Access Compliance Report

Public Rights-of-Way

(Curb Ramps)

Intersection ID: 2853	Main Street: CARDINAL_POINT_RD	Cross Street: BENFIELD_RD	Location: SW
ADA ID: BA32FD55DFAF	Ramp Type: Directional1	Initial Pass/Fail: Pass	Overall Compliance: No
Severity Score: 5.25			
Codes/Mitigation Info/Possible Solution		Field Measurements/Component Compliance

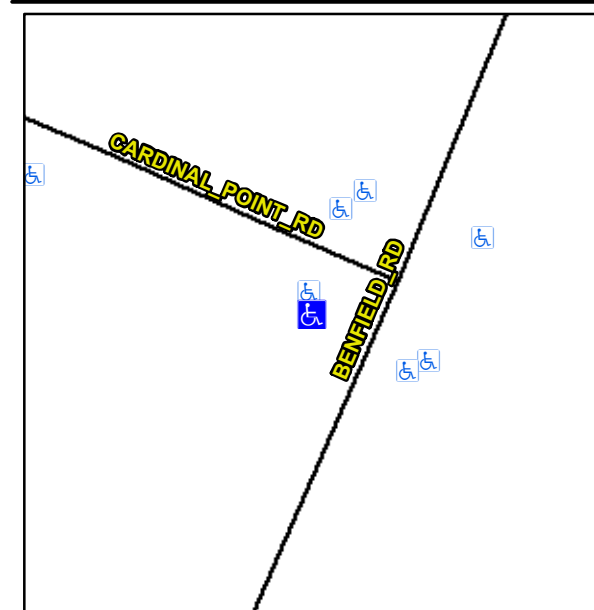
**Remove & Replace Entire Ramp.
Remove & Replace Gutter.**

R304.5.3, R304.2.3

Compliance	Description	Data	Compliance	Description	Data
N/A	Ramp Length (in)	70.0	N/A	Grade Break?	N/A
Yes	Ramp Width (in)	71.0	N/A	Grade Break Slope (%)	0.0
Yes	Ramp Slope (%)	3.2	N/A	Grade Break XSlope (%)	0.0
No	Ramp XSlope (%)	3.3			
Yes	Flare Type LT	N/A	No	Flare Type RT	N/A
N/A	Flare Slope LT (%)	N/A	N/A	Flare Slope RT (%)	N/A
N/A	Flare Traversable LT?	No	N/A	Flare Traversable RT?	No
Yes	Landing Length (in)	77.0	Yes	DWS Provided?	Yes
Yes	Landing Width (in)	72.0	Yes	DWS Contrast?	Yes
Yes	Landing Slope (%)	1.1	Yes	DWS Length (in)	24.0
Yes	Landing X Slope (%)	2.0	Yes	DWS Full Width?	Yes
N/A	Landing Curb? (Y/N)	No	Yes	DWS Offset LT (in)	25.0
N/A	Shared Landing?	Yes	Yes	DWS Offset RT (in)	2.0
Yes	Gutter Ponding?	No	Yes	Gutter Slope (%)	1.9
Yes	Gutter Lip Ht (in)	0.0	No	Gutter X Slope (%)	3.6
N/A	Painted X Walk1?	No		Road Slope (%)	3.4
	X Walk 1 Direction	To SE		Road X Slope (%)	1.1
	X Walk 1 Width (in)	N/A		Clear Space?	Yes
